## TAWHEED CENTER PARKING LOT EXPANSION JSP24-27

Consideration at the request of Turk Architects for Preliminary Site Plan approval. The subject property, located at 24101 Novi Road, is approximately 1.86 acres in size and is situated west of Novi Road, south of Ten Mile Road (Section 27). The property is zoned OS-1 (Office Service District). The applicant is proposing to add 35 new parking spaces and associated landscaping to the north side of the existing 9,750 square-foot building.

# PLAN REVIEW CENTER REPORT

Revised Preliminary Site Plan

**DUMPSTER ENCLOSURE PLAN**  
**1/4" = 1'-0"**

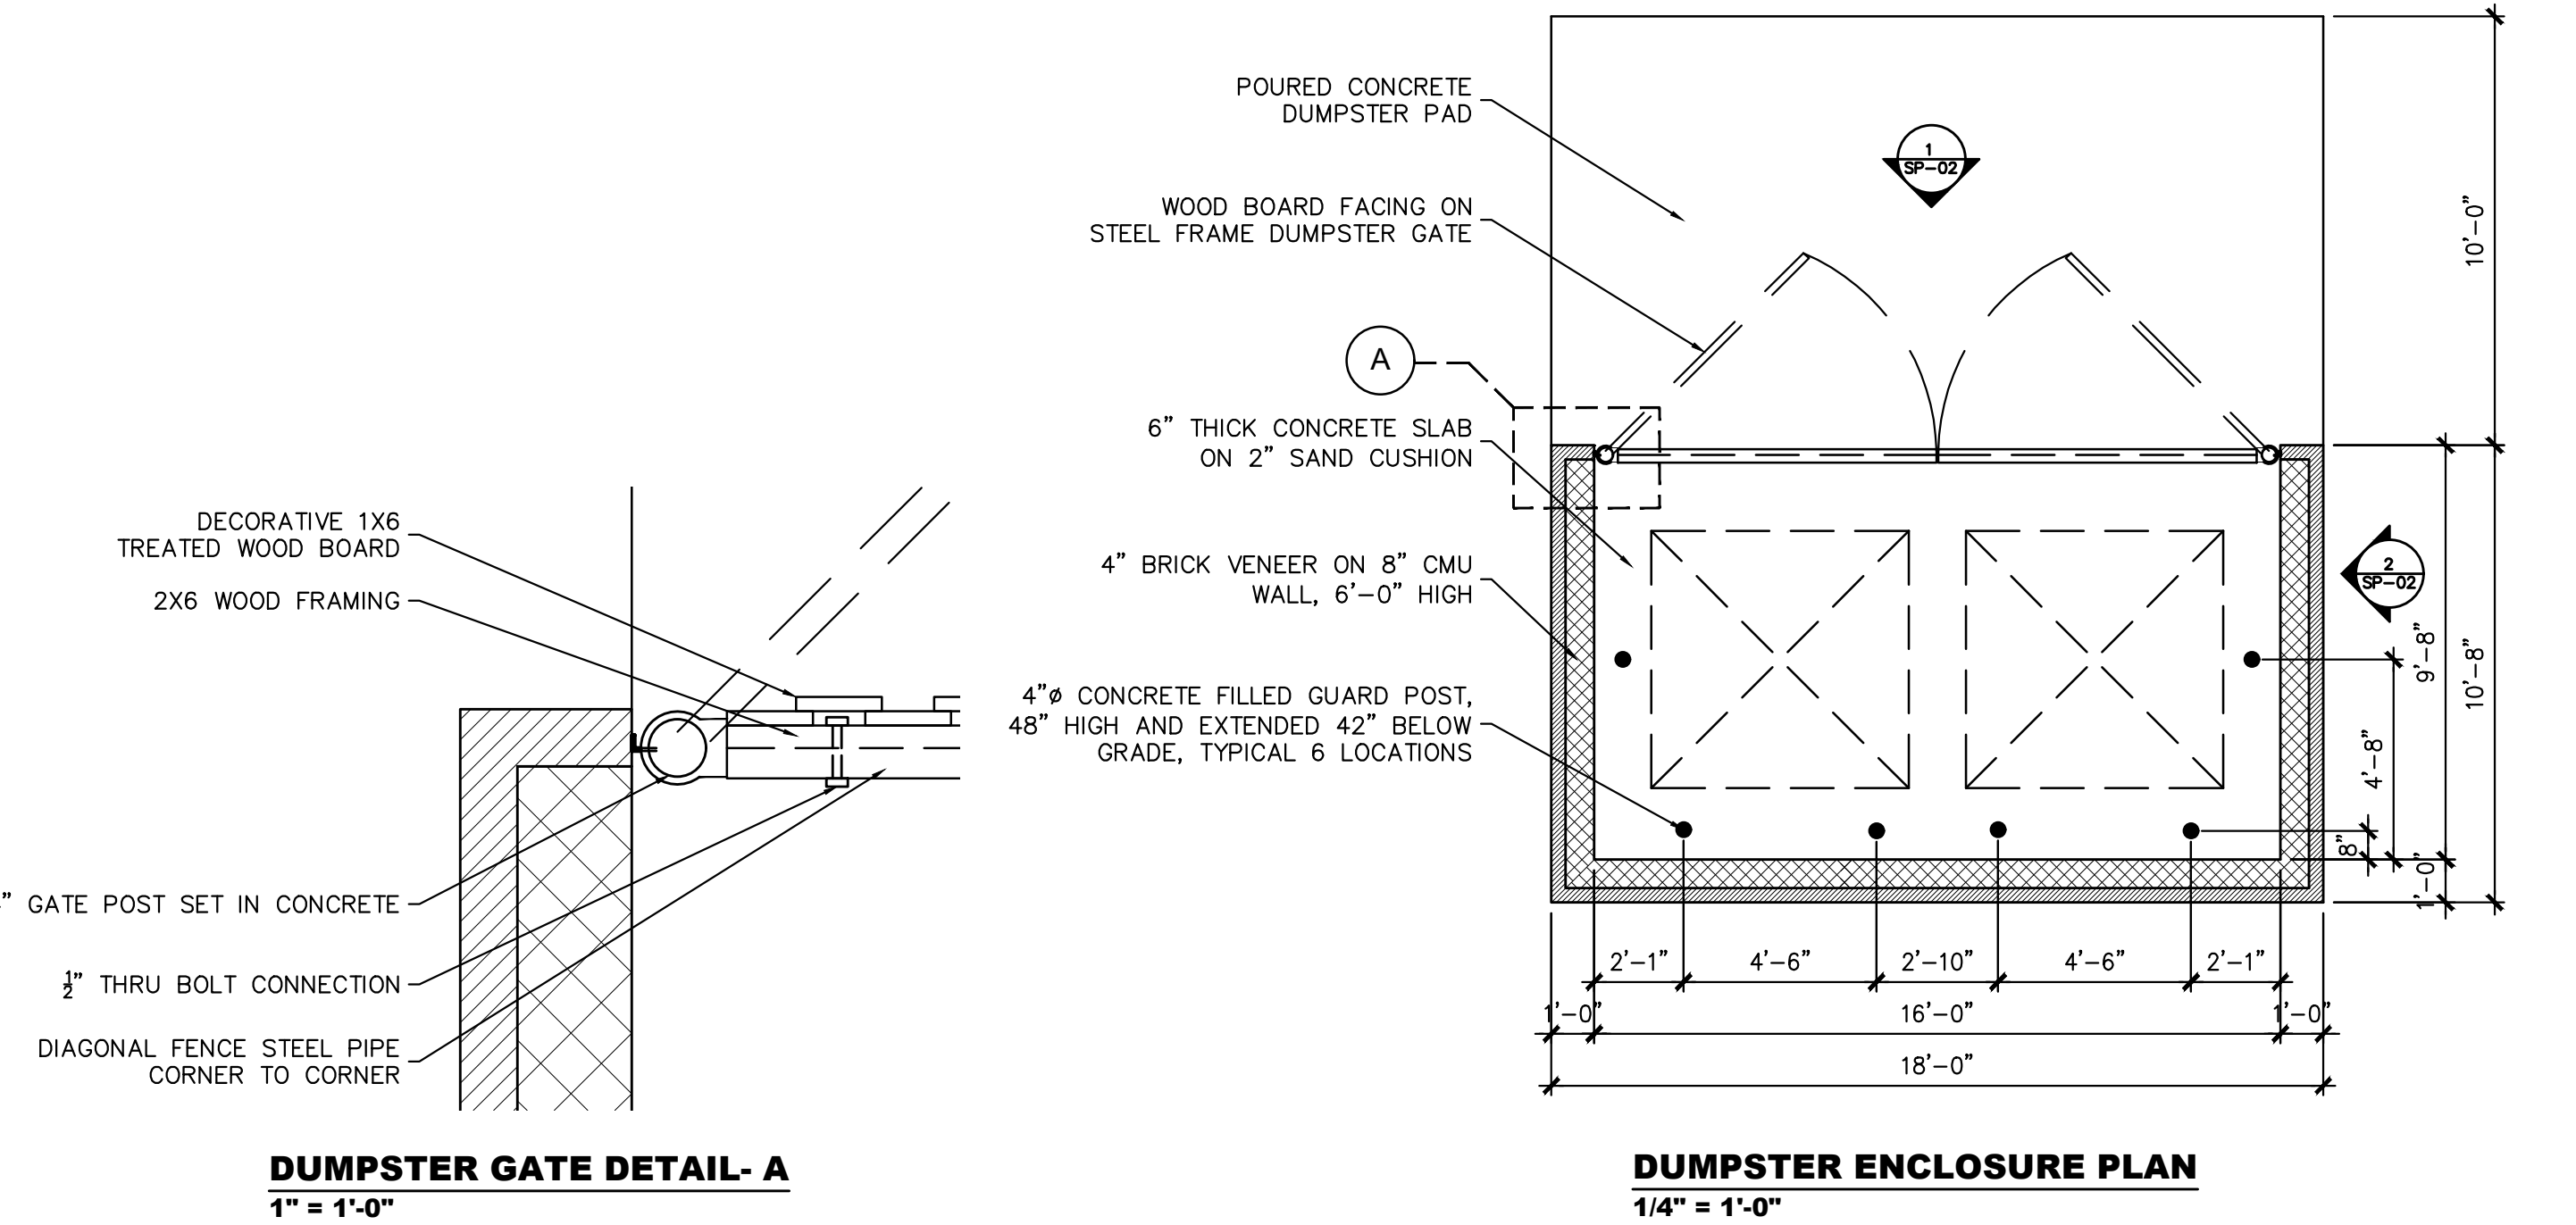
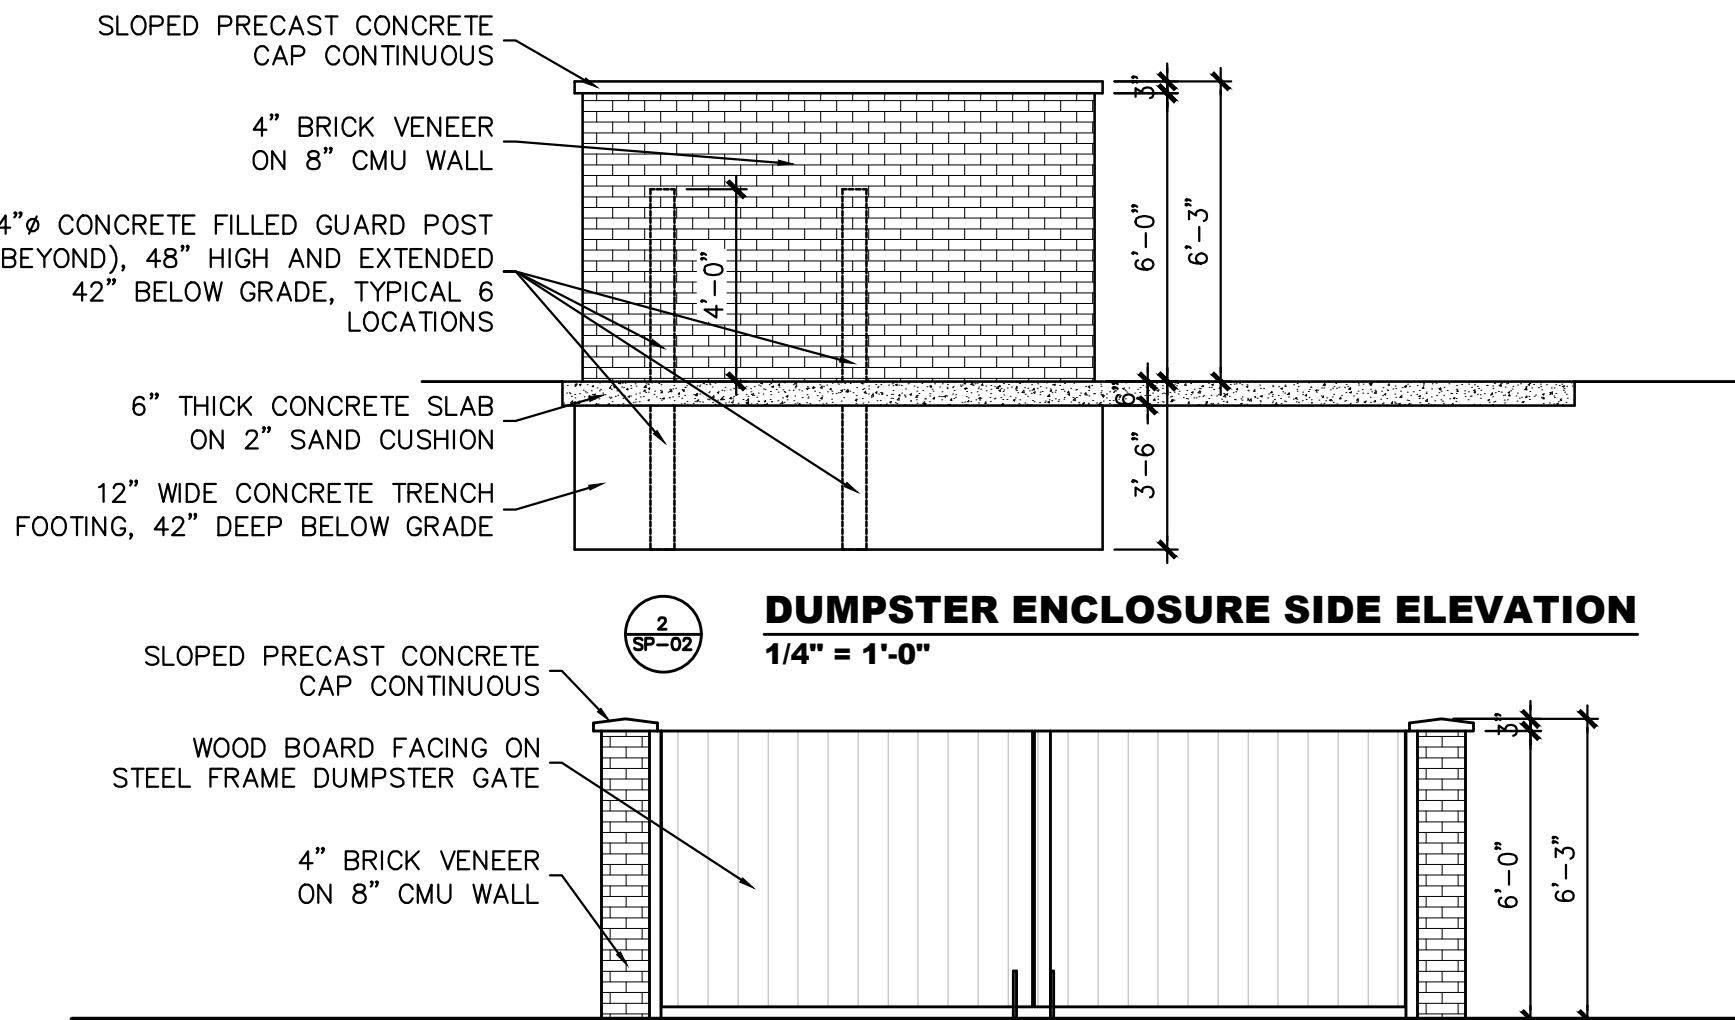
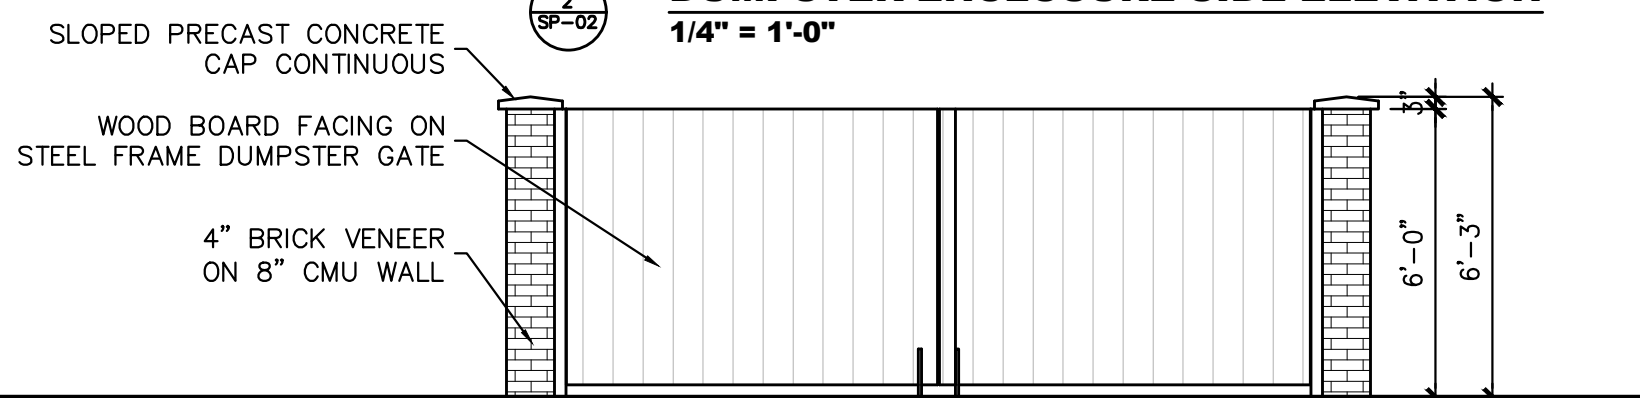
2. Dumpster (Section 4.19.2.F): Shall be located in rear yard or interior side yard in case of double frontage. The existing dumpster is in the exterior side yard. The dumpster should be relocated to meet ordinance requirements, since additional changes are made to this part of the site and the dumpster may interfere with the increased traffic movements shown on the plan. **Dumpster relocated to the southwest corner of the site.**
